The Commission has issued the enclosed Amendment Nos. 84 and 71 to Facility Operating License Nos. NPF-4 and NPF-7 for the North Anna Power Station, Units No. 1 and No. 2 (NA-1&2). The amendments revise the Technical Specifications (TS) and the licenses in response to your letters dated May 2, 1985, as supplemented February 6, April 30, June 4, and July 3, 1986.

The amendments revise the NA-1&2 Facility Licenses No. NPF-4 and No. NPF-7 and the Technical Specifications (TS) to increase the presently rated core power level of 2775 Megawatts-thermal (MWt) to 2893 MWt. The amendments allow NA-1&2 to operate at a Nuclear Steam Supply (NSSS) power of 2905 MWt. The amendments will increase the electrical power output for each unit by 32 Megawatts-electrical (MWe).

NORTH ANNA POWER STATION, UNIT NO. 1

Amendment No. 84
License No. NPF-4

Figure 2.1-1 REACTOR CORE SAFETY LIMITS FOR THREE LOOP OPERATION

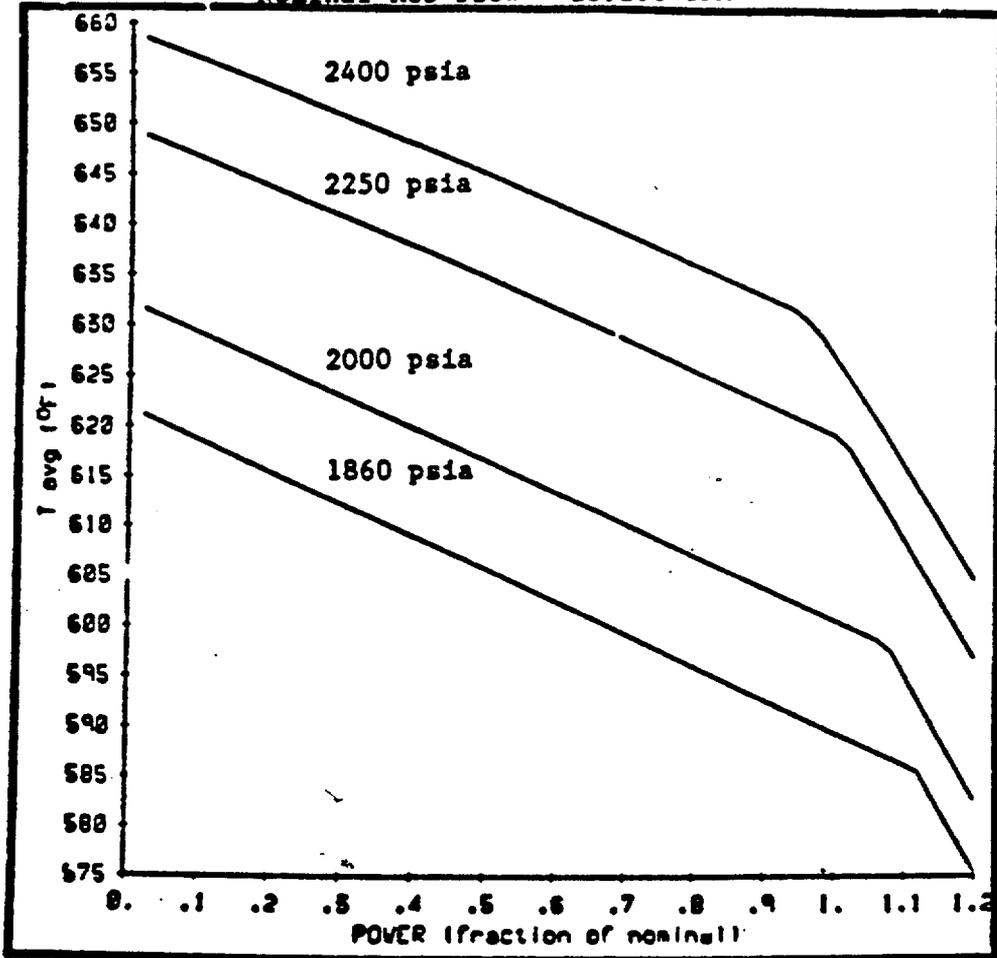
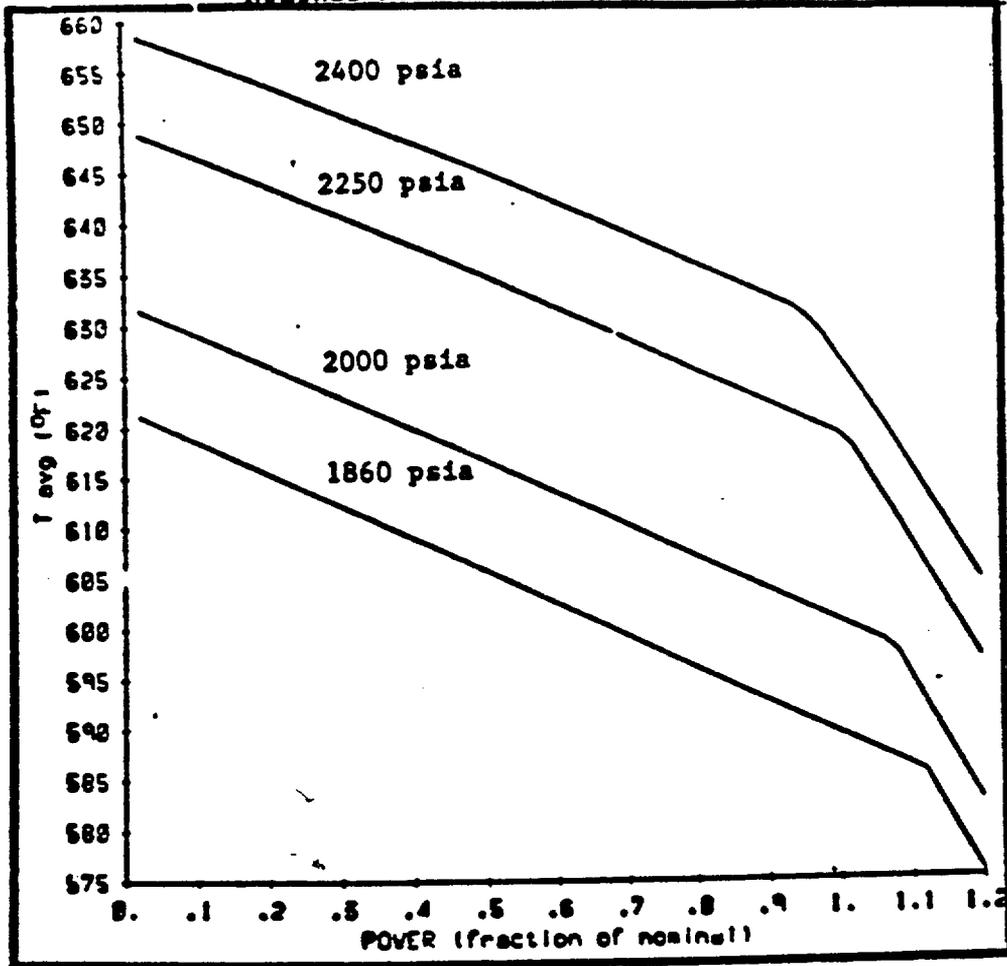
- b. Page 2-2, (2-2). This change appropriately adjusts the figure defining the reactor core safety limit (maximum allowable temperature as a function of pressure and power) for uprated power, and nominal design flow of 289,200 gallons per minute (gpm).

Nominal $T_{avg} = 586.8^{\circ}F$
Nominal RCS flow = 289200 GPM

Figure 3.2-2 NORMALIZED $F_Q(z)$ AS A FUNCTION OF CORE HEIGHT

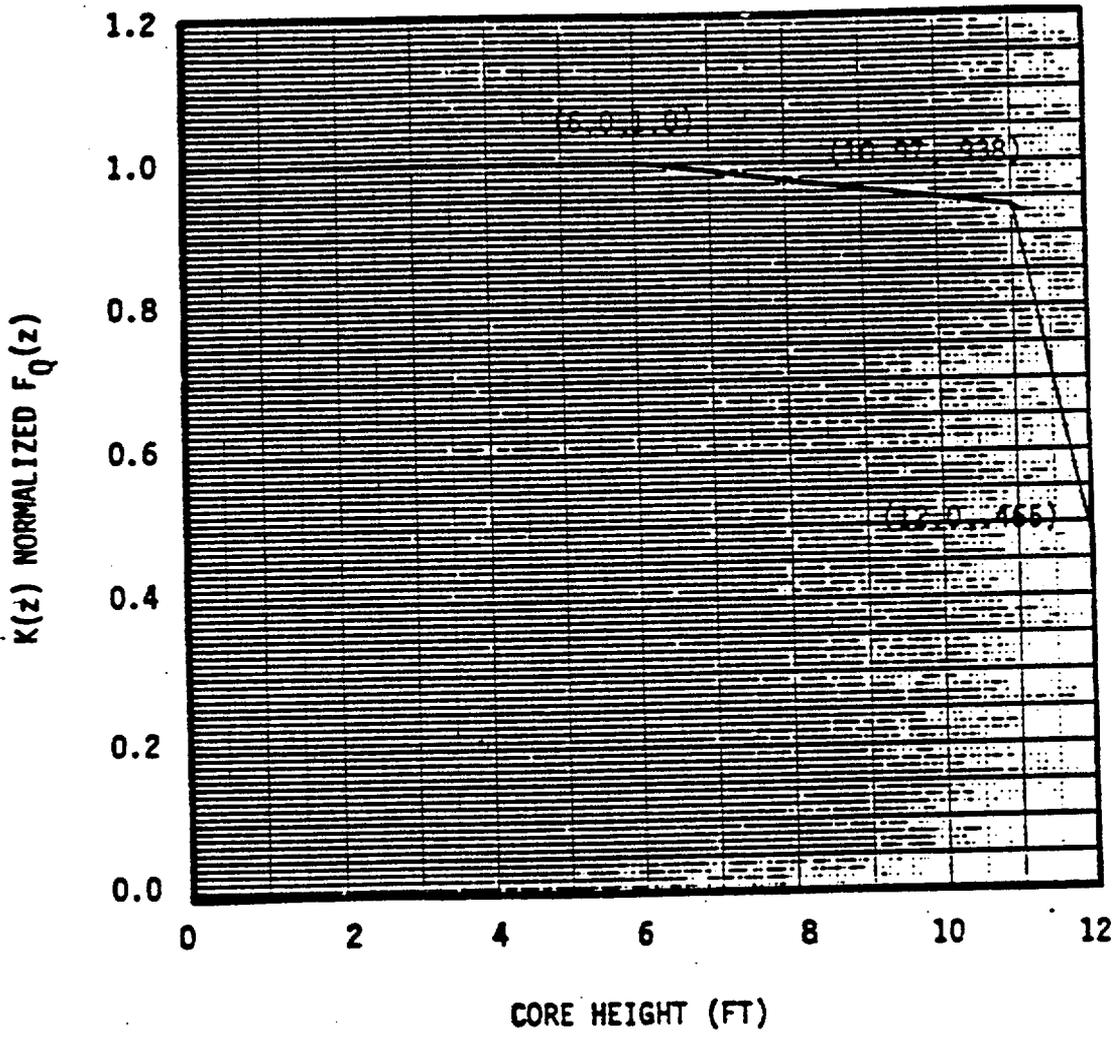
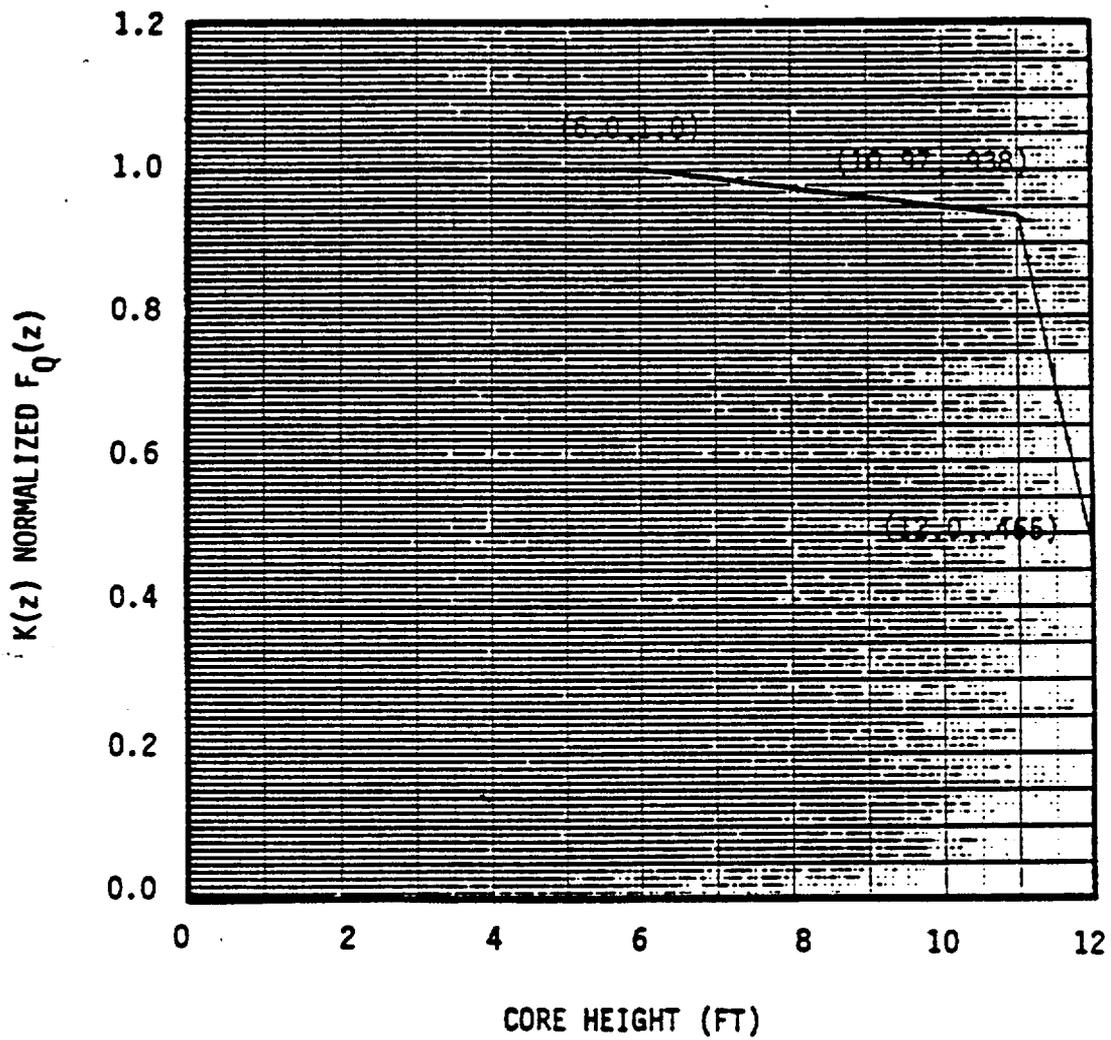
- i. Pages (3/4 2-6, 3/4 2-7). The changes on these pages adjust the maximum allowable $F_0(z)$ value to 2.15.
- j. Page 3/4 2-8, (3/4 2-8). This change provides a new normalized $K(z)$ curve reflecting the change in $F_0(z)$ in the previous two items.
